**Assessment of the Influence
of Dewatering at Bailly N-1**

D'APPOLONIA

Project No. MW79-720
November, 1980

FIGURE 5

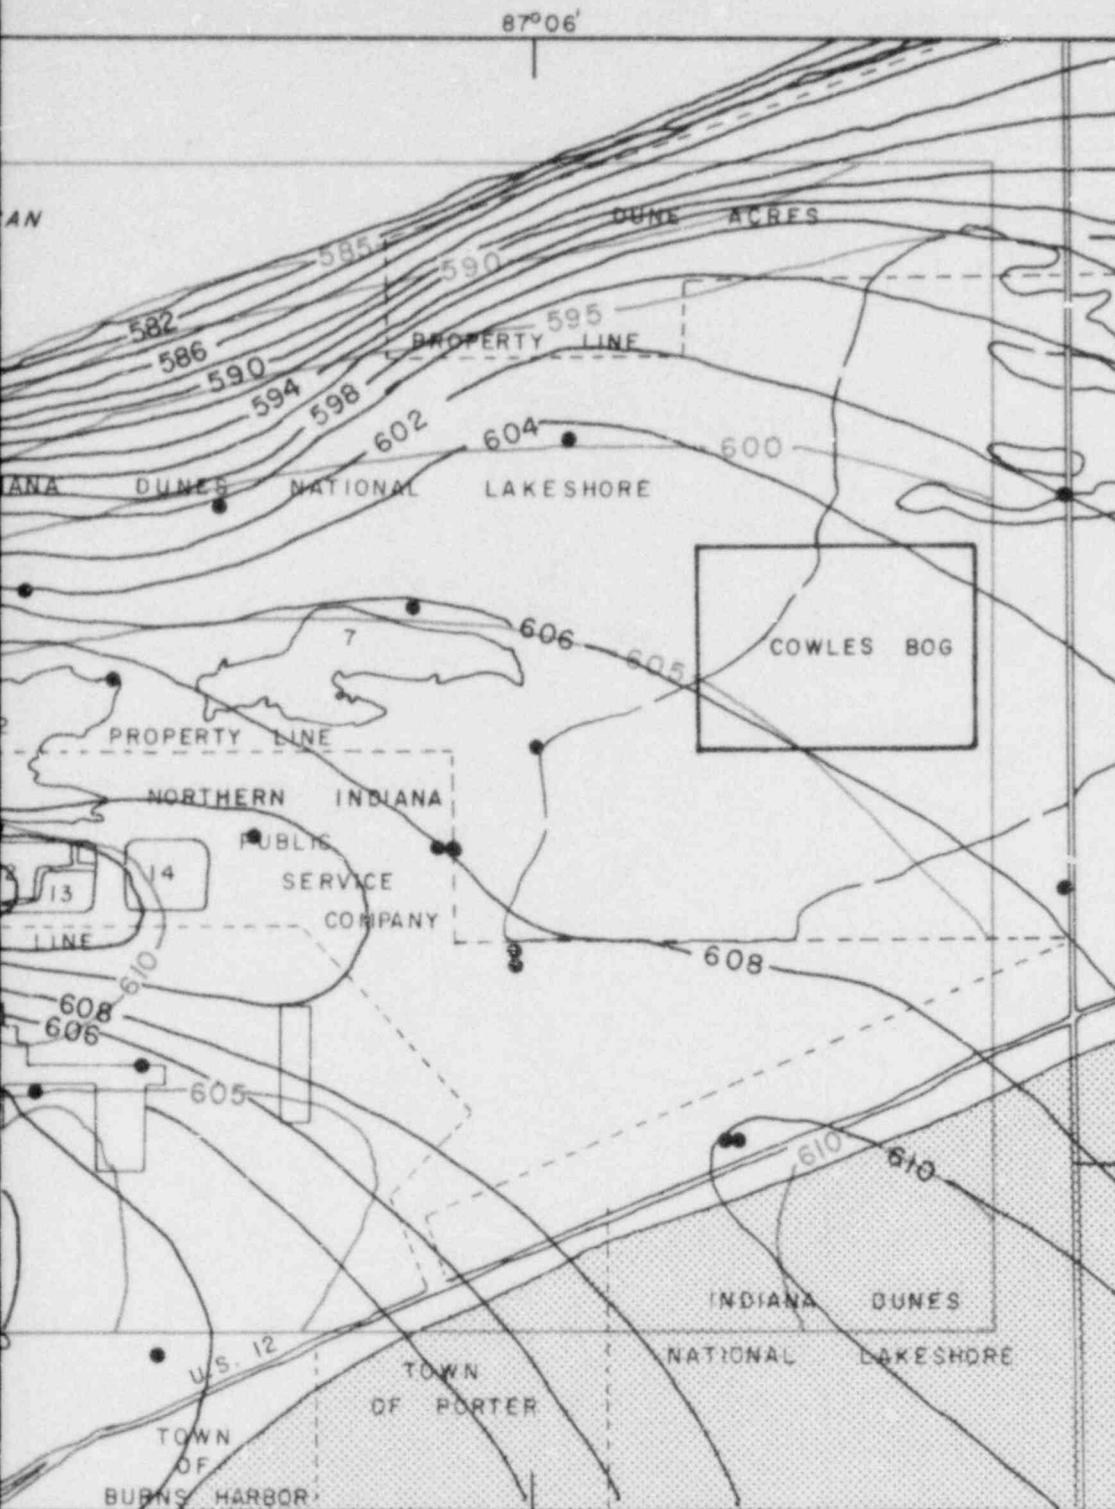
In Reference 1, Figures 13 and 25 show only one well while Figures 16 and 26 show three wells (See Figures 5 and 6, this report). All these figures are for water levels on October 26, 1976. Table I (Page 49, Reference 1) shows four wells to be active on that date. The USGS is aware that all of these wells are fully gravel-packed (Pages 15 and 49, Reference 1). Therefore, all the wells are pumping from both Unit 1 and Unit 3, yet in Table I the USGS lists wells 6 and 73 as pumping only from Unit 3. Accordingly, the model derived water levels as presented in Figures 25 and 26 are incorrect, as the well data has been incorrectly incorporated into the study.

Figures 13 and 25 (Reference 1) then show groundwater levels for Unit 1 in the area where Unit 1 is supposedly absent. Obviously this is incorrect (Figure 5 of this report).

FIGURE 6

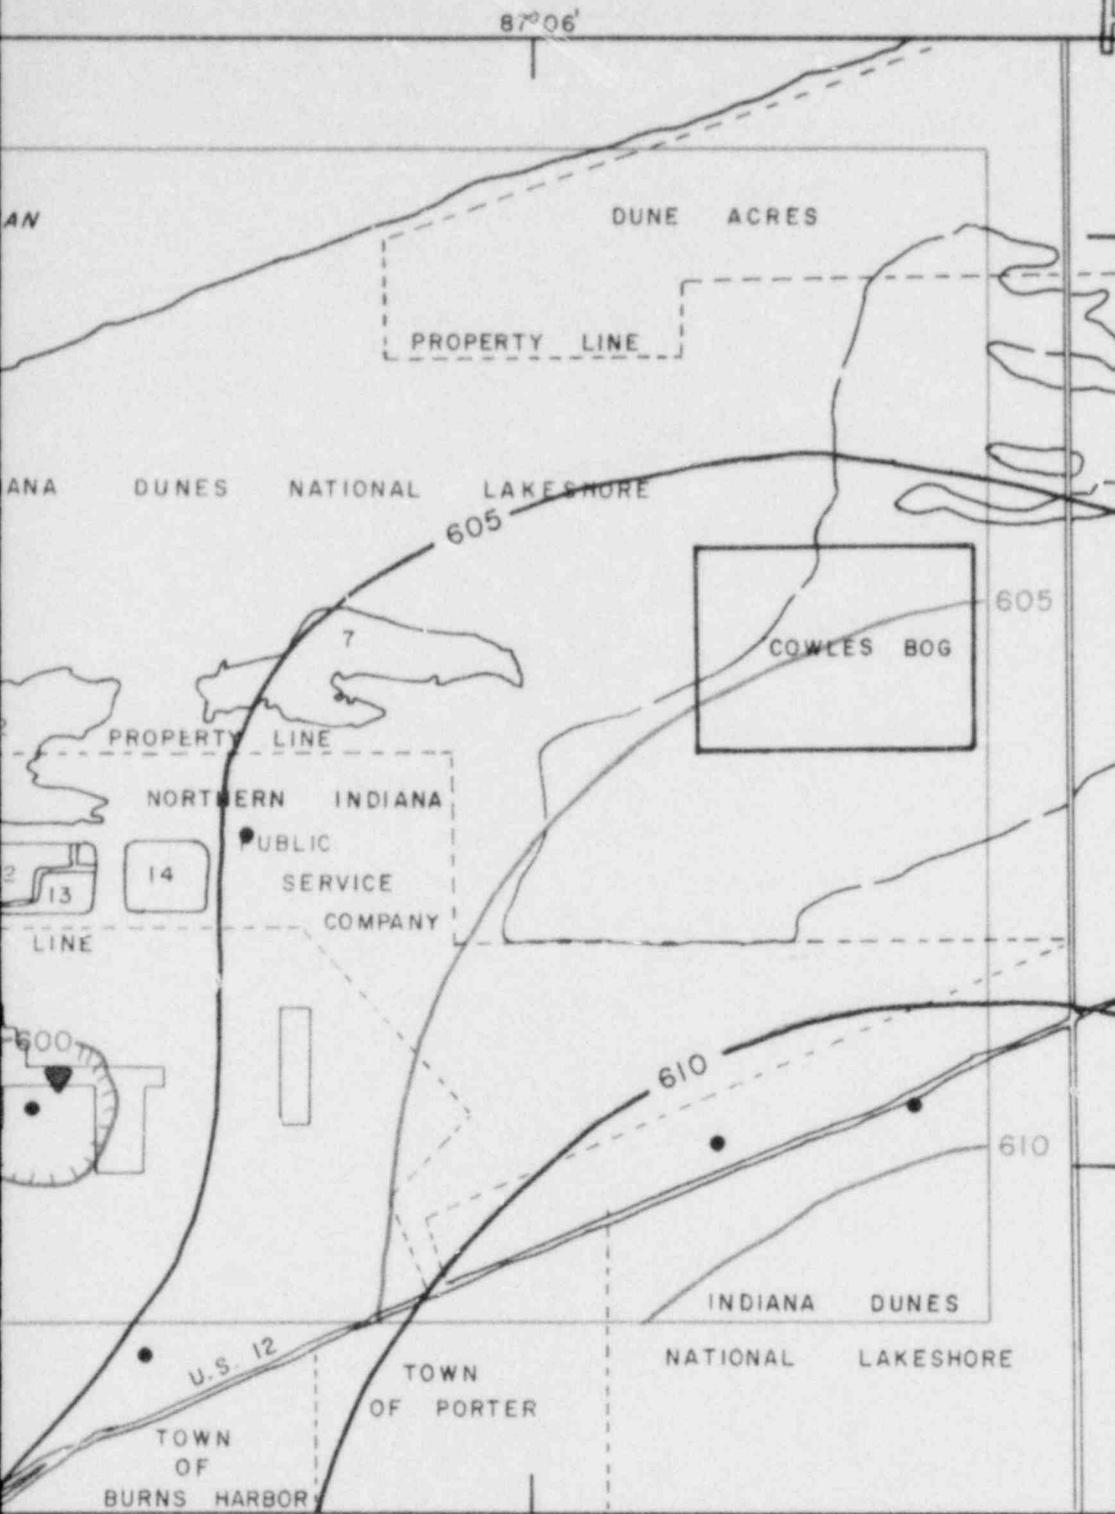
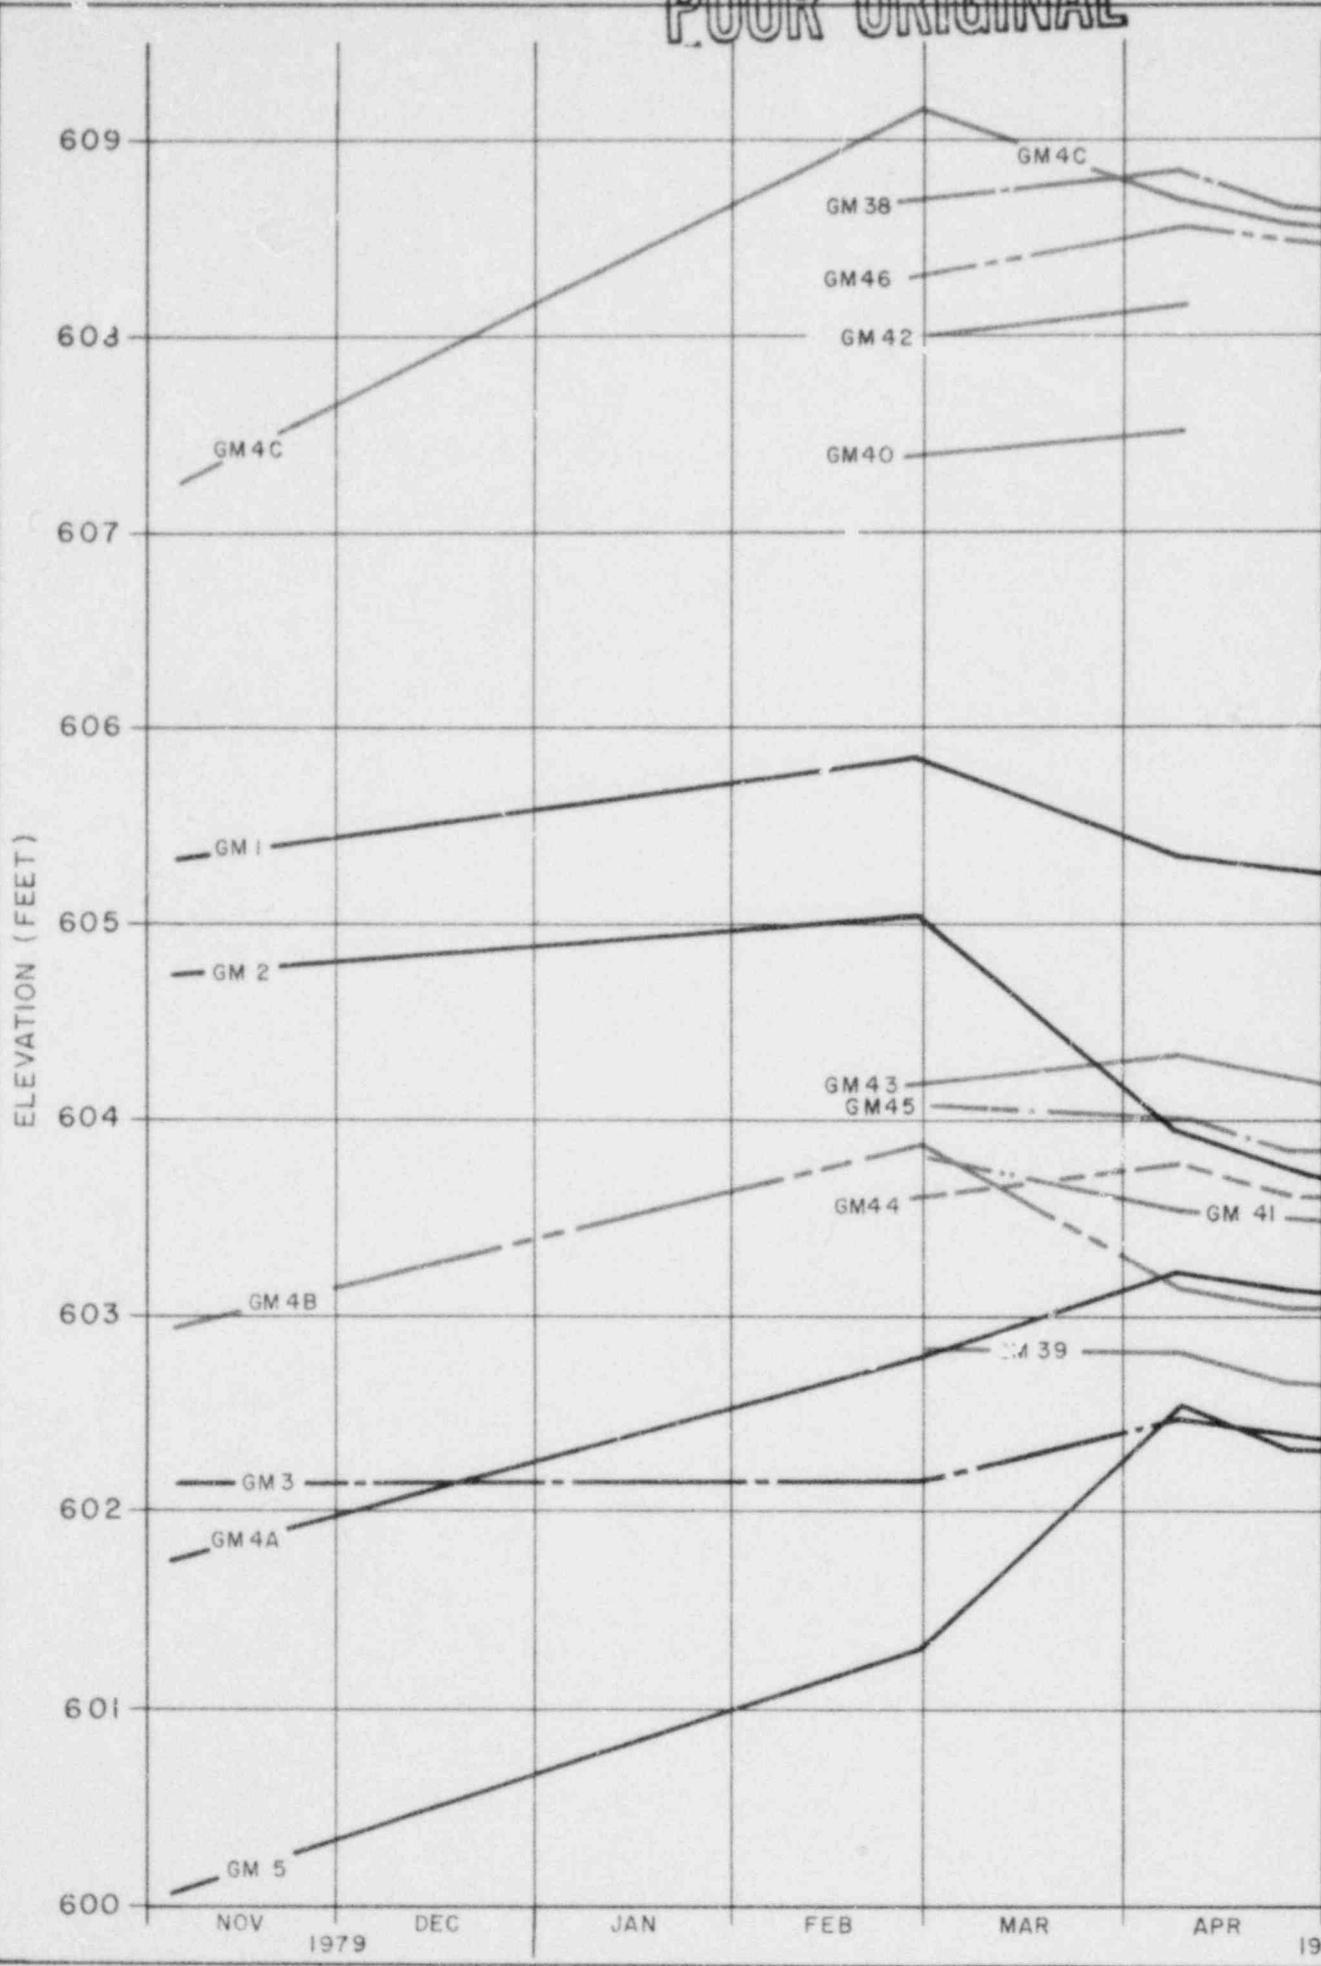
Figure 16 shows observed water levels in Unit 3 (see Section 3.1.5) for October 26, 1976, and Figure 26 shows the model derived water levels for the same time. Data from these two figures is summarized and presented in Figure 6 of this report. It can be seen that water levels in Unit 3 are not in good agreement particularly for model calibration and that groundwater levels for Unit 3 are shown in the area where Unit 3 is absent north of Bailly N-1.

FIGURE 7
RECORDED WATER LEVELS
IN THE GREAT MARSH AREA
PIEZOMETERS
BAILLY GENERATING STATION
NUCLEAR 1
PREPARED FOR
NORTHERN INDIANA
PUBLIC SERVICE CO.

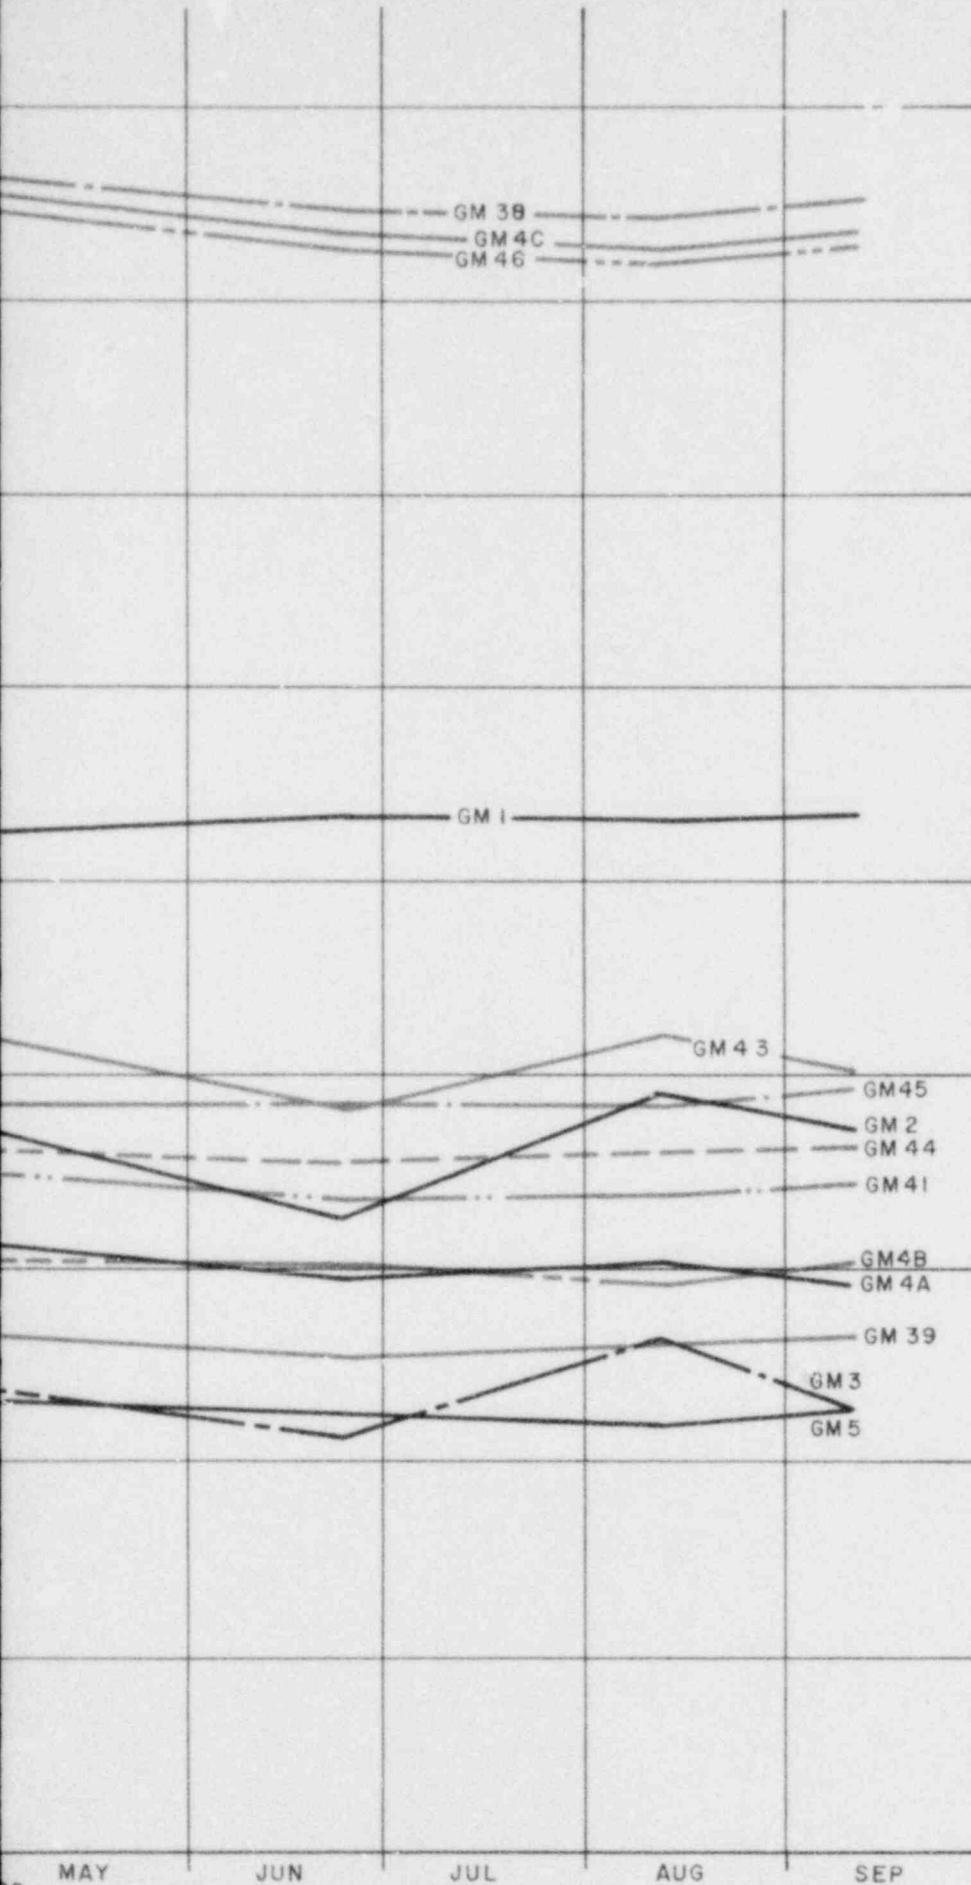
Water levels for 16 USGS piezometers (screened in Unit 1) are plotted on Figure 7. Eleven piezometers are inside the bog and five are in the marsh area surrounding it. The maximum difference between water levels measured in the bog is approximately six feet and in the marsh area, approximately five feet. In November 1979, the piezometers inside and outside the bog area show the lowest readings, and in March 1980 the highest. The changes are in the range of 1 to 2 feet. This apparently represents the seasonal change for that period and is typical for the area. The water level changes in piezometers (Figure 7) follow the same general trend and do not exhibit any anomalies inside or outside Cowles Bog. In turn, this indicates that changes in water level in the bog area are reflected in the marsh area. If it is assumed that the USGS computer model simulations are correct in predicting water level changes in Cowles Bog, the changes will be offset by recharge with marsh water before they can occur. It is unrealistic to predict any water level changes in the bog area without taking into account the surrounding marsh water.

FIGURE 7 REPRODUCED
 FROM USGS REPORT 78-138

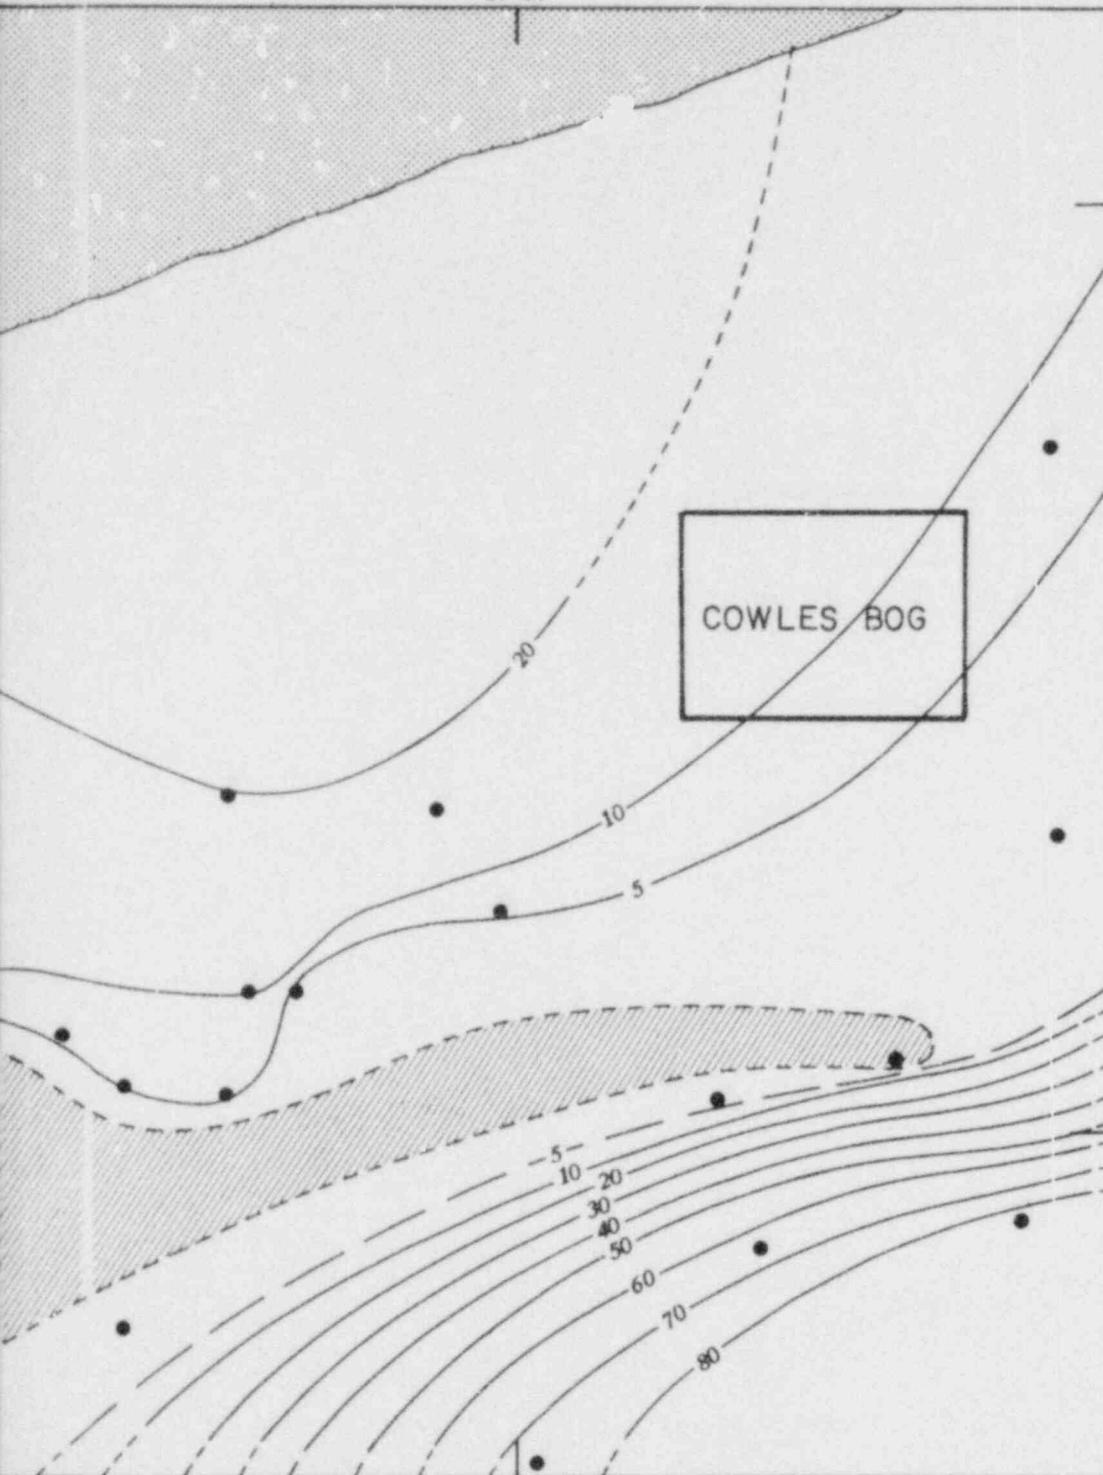
Even assuming that the USGS hypothesis is correct regarding a "discontinuity" of Unit 2 at the bog, this would not be unique as Unit 2 is absent in many locations (as a small or large opening) throughout the study area (References 1, 2 and 3). Both USGS reports show Unit 2 as being absent in the southern half of the study area (Figure 7, Appendix B).
